**MEMORANDUM**  
**OFFICE OF THE STATE ENGINEER**  
*Hydrology Bureau*

SUBJECT: Plugging and abandonment of well B-700-POD1 in the Bluewater  
Underground Water Basin, Cibola County, New Mexico.

Figure 1: Alluvial Groundwater Elevation Map surrounding the B-700 well; modified from Bingham (2022a).

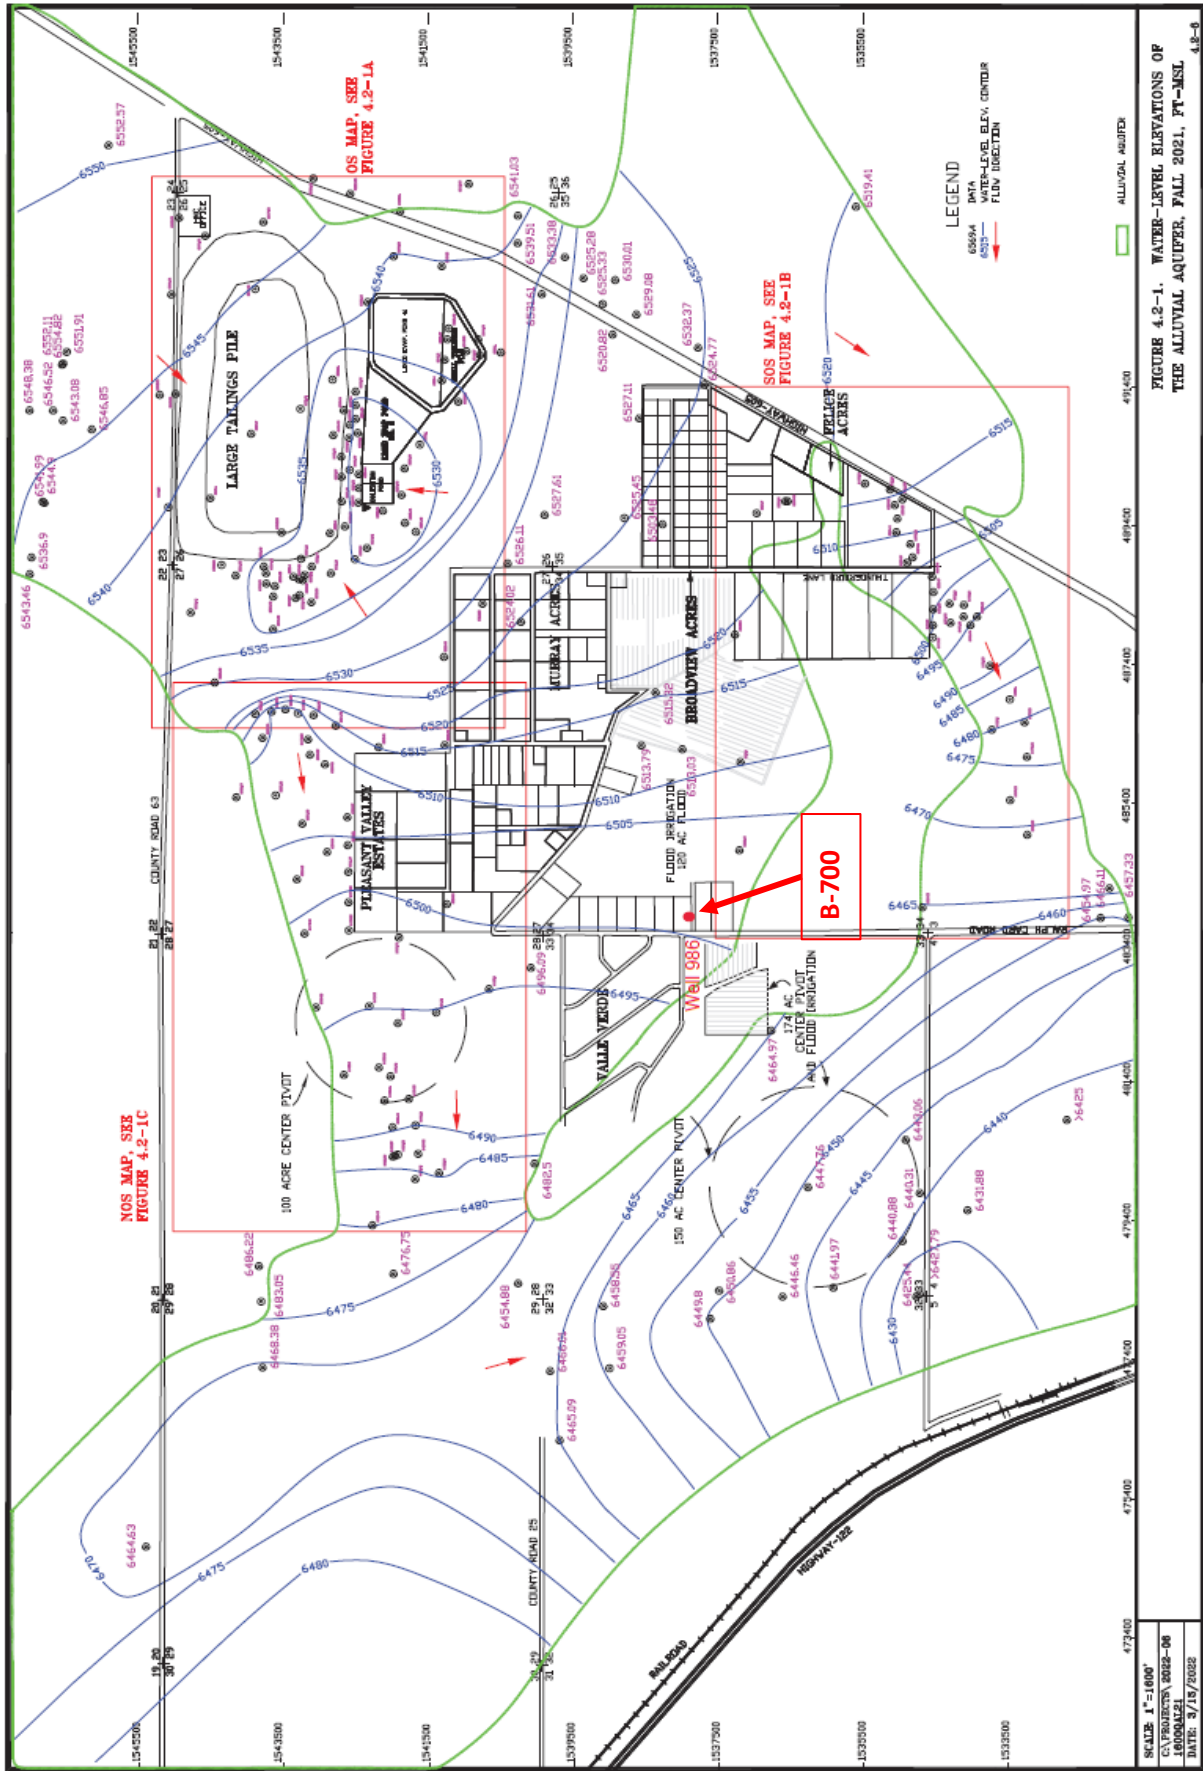
The alluvial aquifer appears to pinch out to the south and southwest of well B-700 (Figure 1). The groundwater flow direction north of the pinch out appears to be in a westerly direction and south of the pinch out in a southeasterly direction. Northeast of the well near the large tailings pile there appears to be a cone of depression. Based on the alluvial groundwater uranium concentration map (Figure 2), the nearest up-gradient contamination that exceeds the site standard of 0.16 mg/l is to the east of the B-700 approximately 1.0 mile. In addition, should the cone of depression cease to exist, groundwater and uranium concentrations may start to flow in the direction of well B-700.

Groundwater elevation maps (Figure 1, Figure 3 and Figure 6) indicate that there is a downward gradient from the alluvium through the lower Chinle and into the SAG. Based on the uranium

Figure 2: Alluvial Groundwater Uranium Concentration Map surrounding the B-700 well; modified from Bingham (2022a).

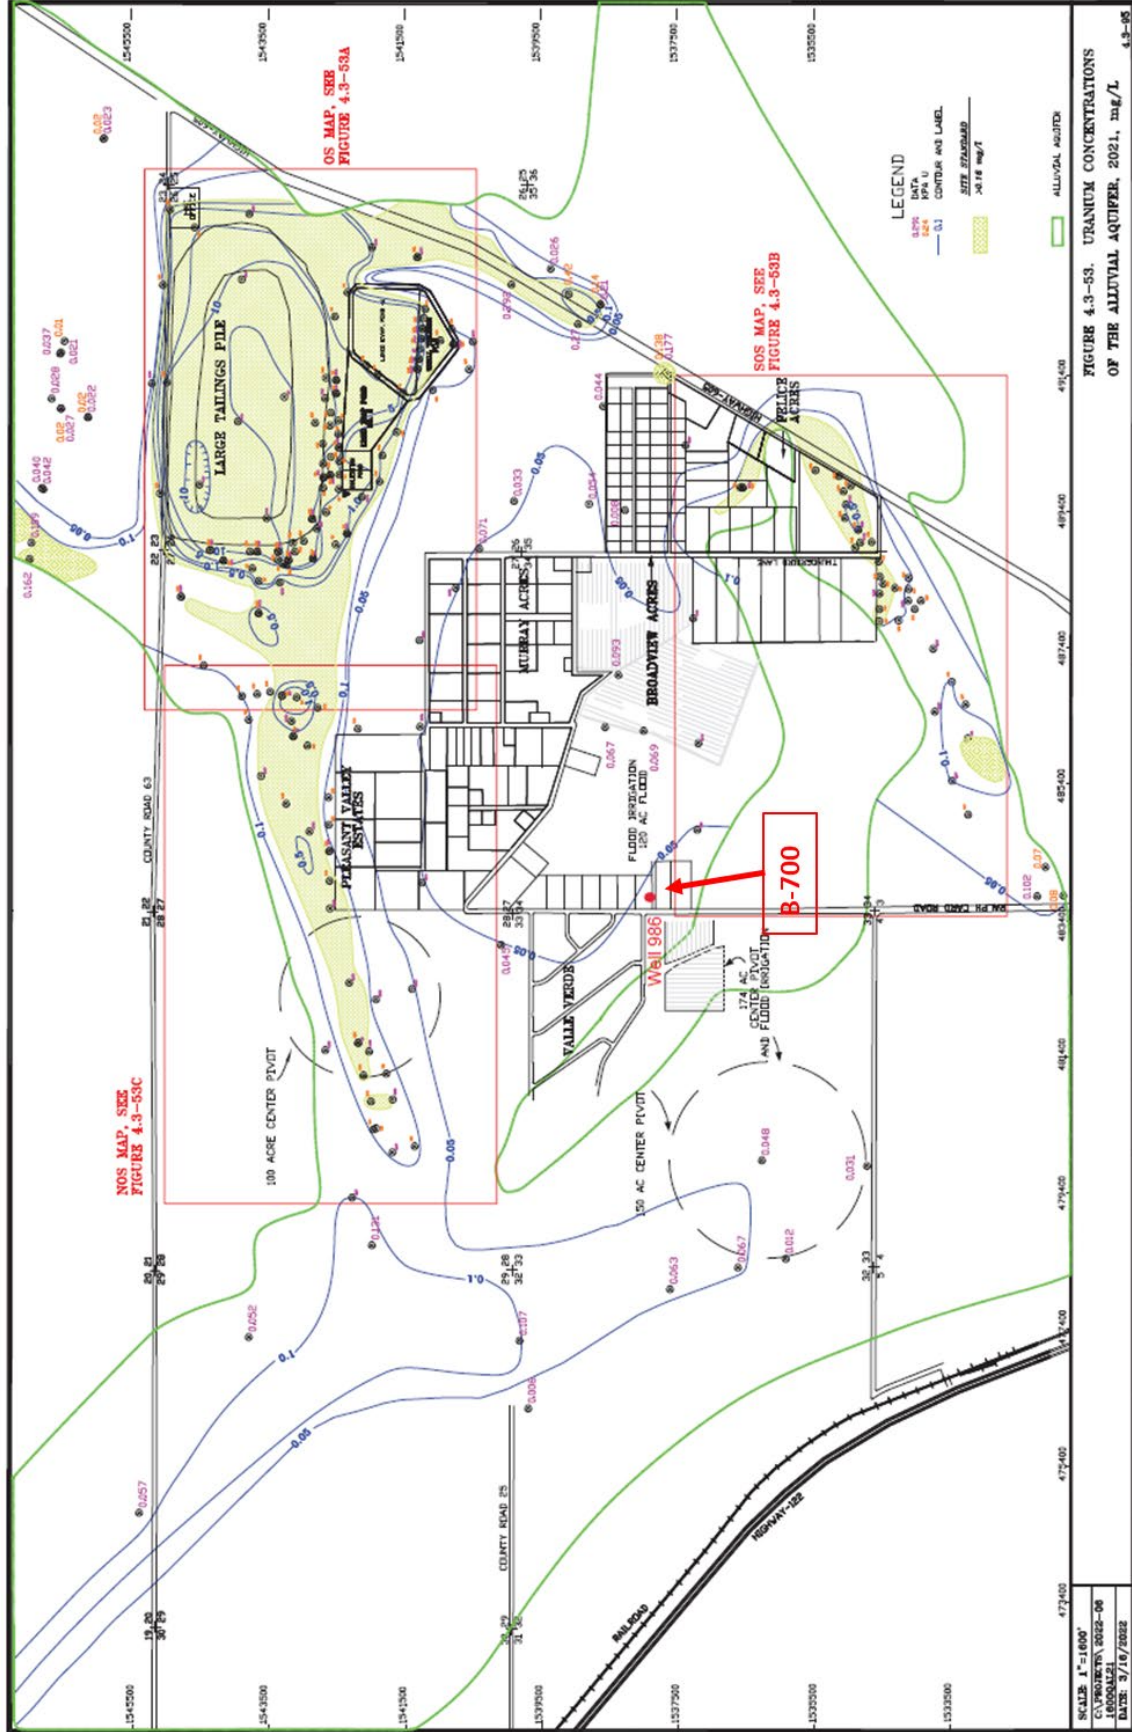
concentration maps (Figure 2, Figure 5 and Figure 7) the alluvium, lower Chinle and SAG exceed the New Mexico Groundwater Standard of 0.03 mg/L at the B-700. Therefore, if the alluvial aquifer remediation system identified in Weaver et al. (2022) was discontinued groundwater gradients would likely change increasing the possibility of even higher uranium concentrations moving towards well B-700 and possibly contaminating the SAG. Even if the contamination did not move towards the well, an improperly plugged well does not comply with NMAC 19.27.4.29 as it may result in a loss of hydraulic head, inter-aquifer exchange, and potential for contamination entering the wellbore.

Figure 6: San Andes/Glorieta Groundwater Elevation Map surrounding the B-700 well; modified from Bingham (2022a).

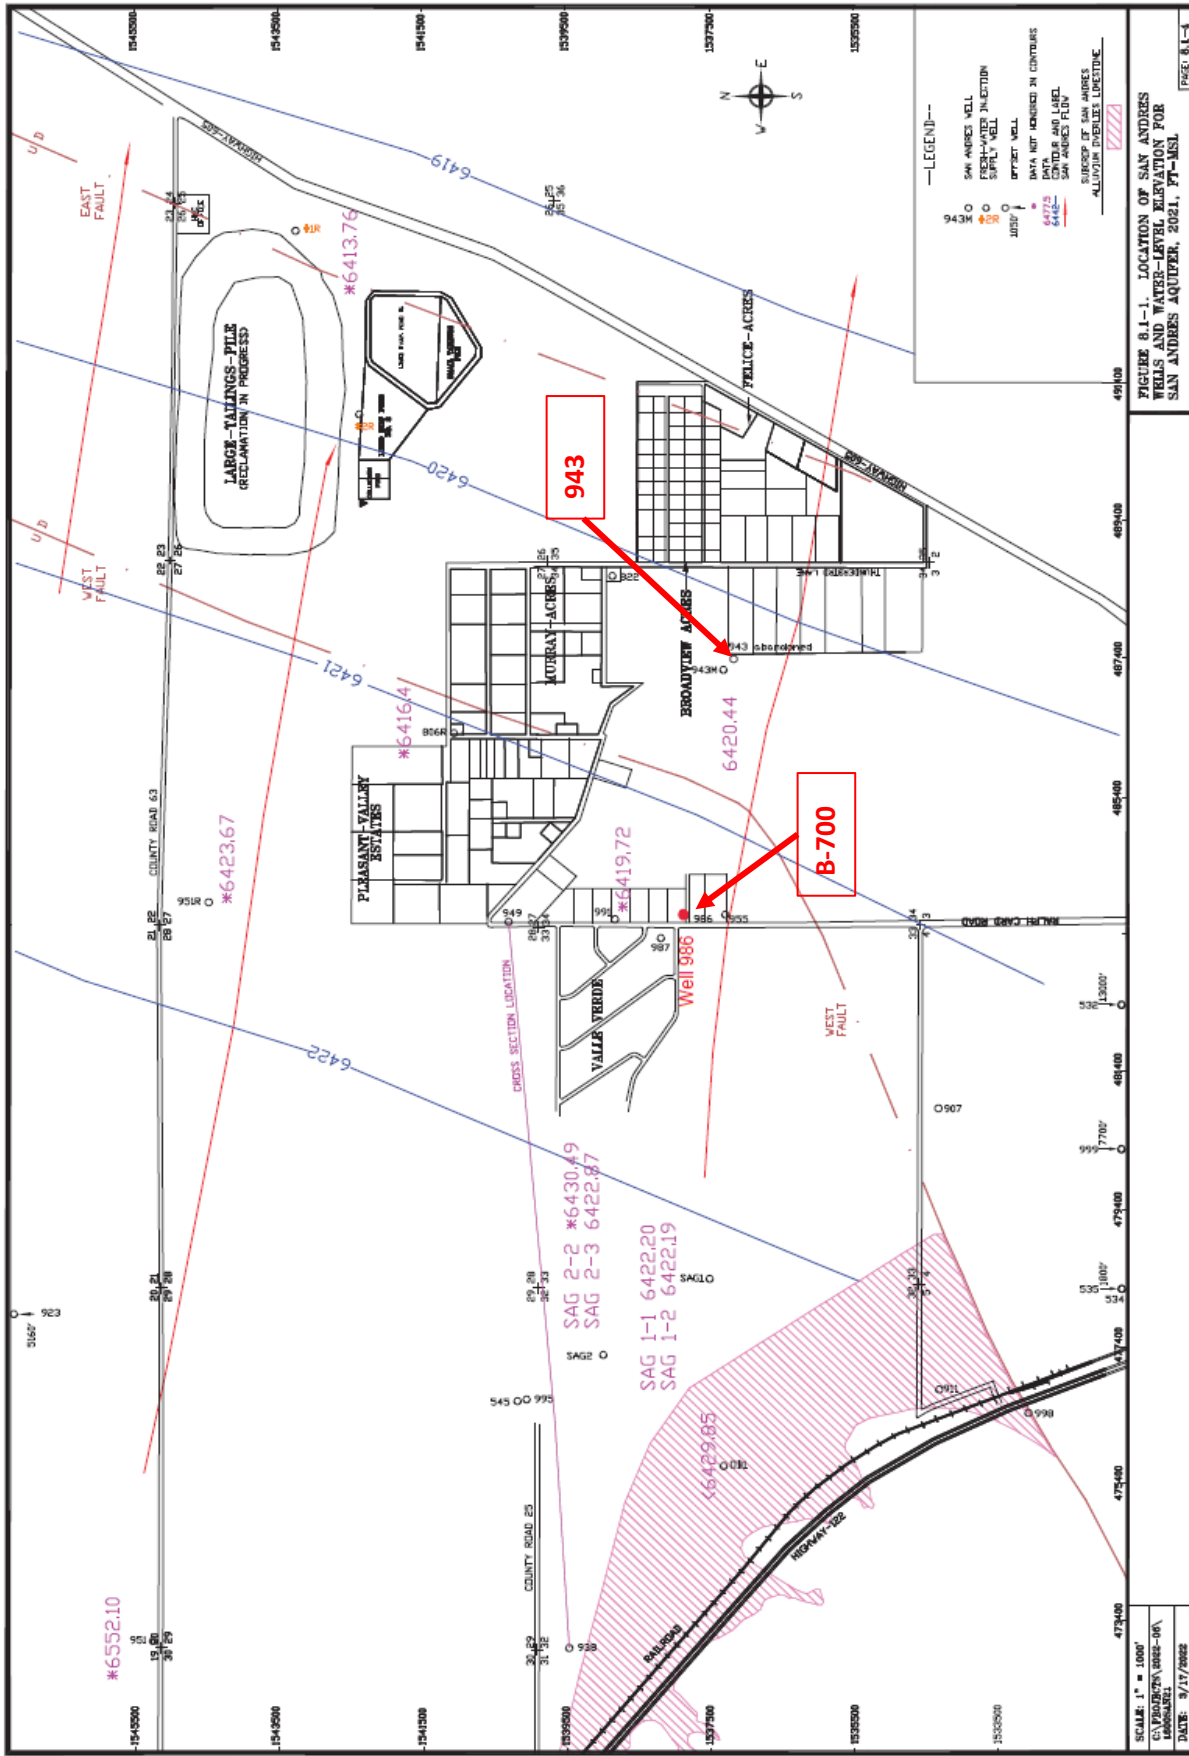
The SAG aquifer at the location of well B-700 appears to flow to the east. The alluvium and SAG appear to be hydraulically connected to the west of the B-700 (Figure 6). Several groundwater elevation data points were not honored in the applicant's potentiometric surface interpretation (Figure 6). No reason was found for the applicant's decision to not honor these data points. According to the applicant's potentiometric surface map, the West Fault does not appear to affect the groundwater flow as the saturated thickness of the aquifer is greater than the vertical off-set of the fault (Weaver et al., 2022). Based on Weaver et al. (2022), well 943 (Figure 6) was not

Figure 7: San Andres/Glorieta Groundwater Uranium Concentration Map surrounding the B-700 well; modified from Bingham (2022a).

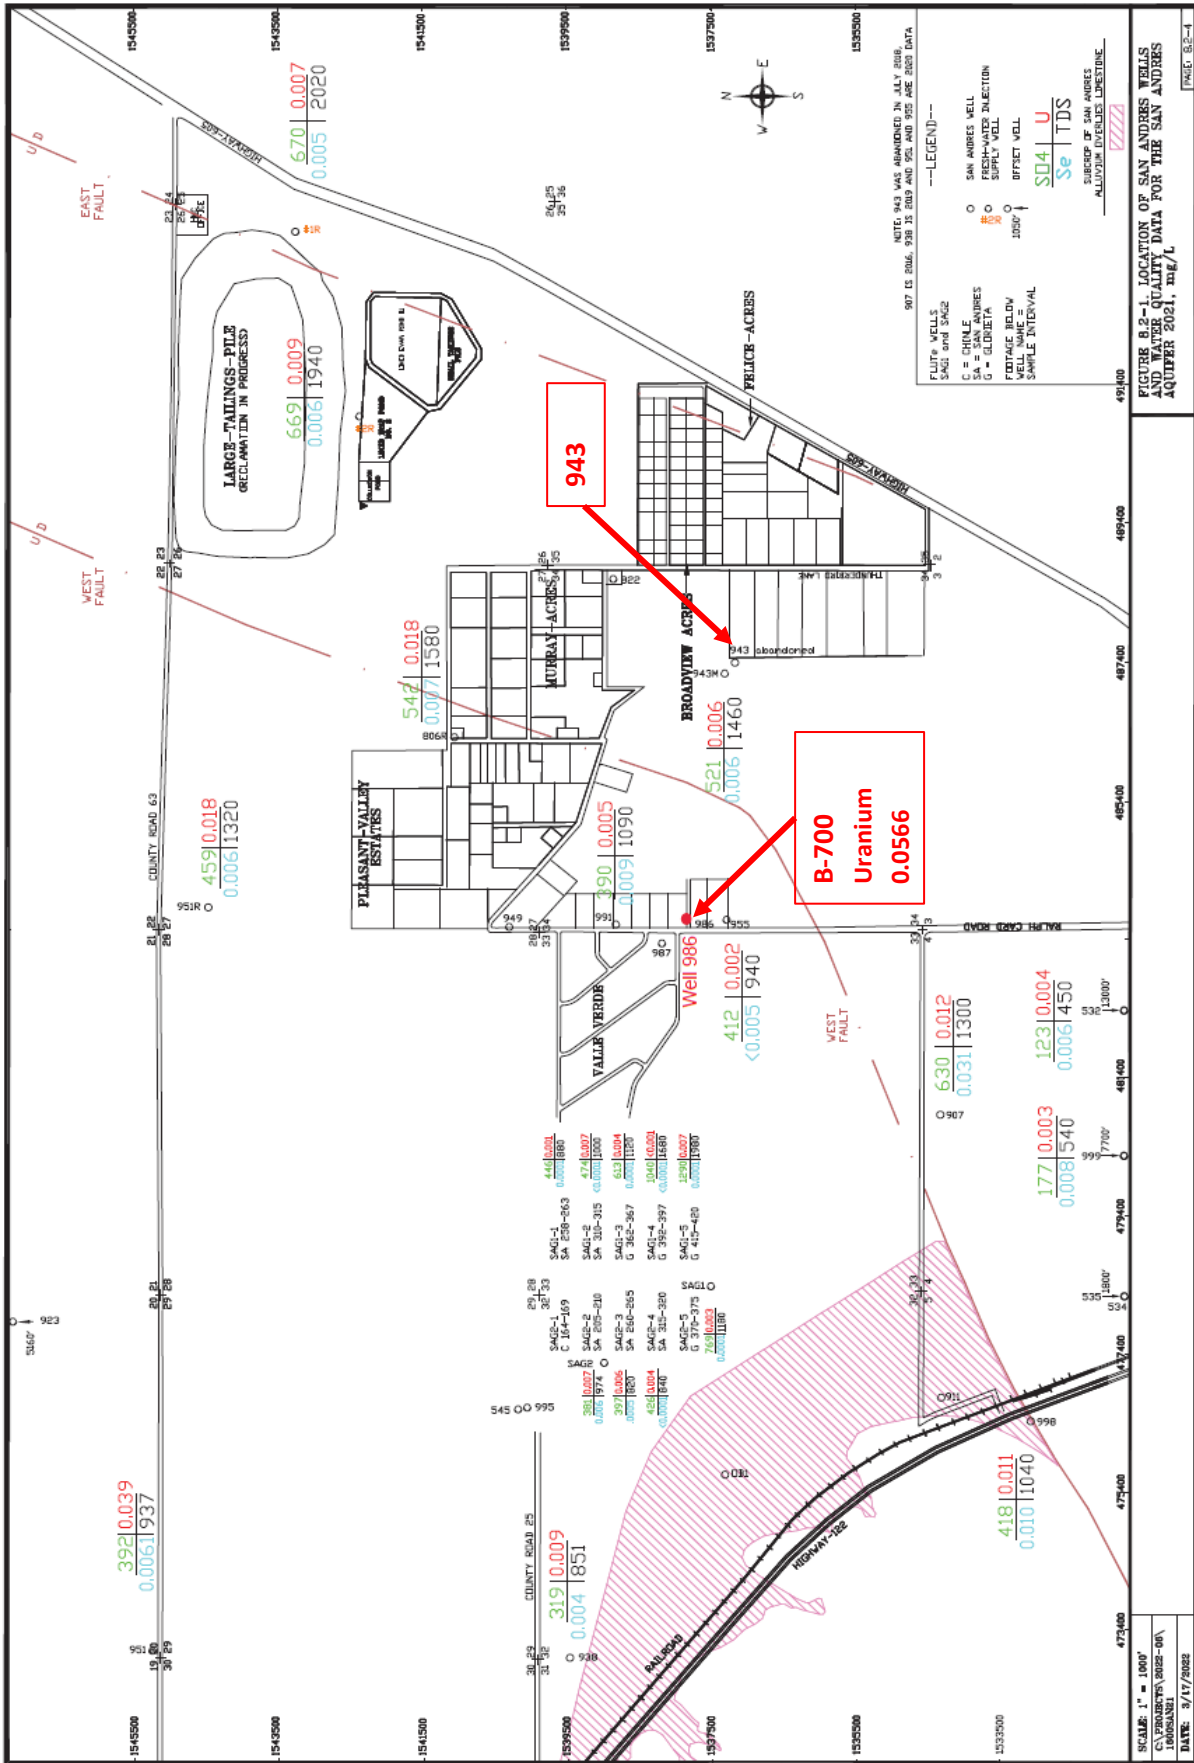
adequately sealed between the alluvial aquifer and the SAG which resulted in a slight contamination to the SAG. This appears to be occurring at the B-700 well as the March 2022 uranium concentration is 0.0566 mg/L, which greater than the New Mexico groundwater standard and surrounding wells (Figure 7).
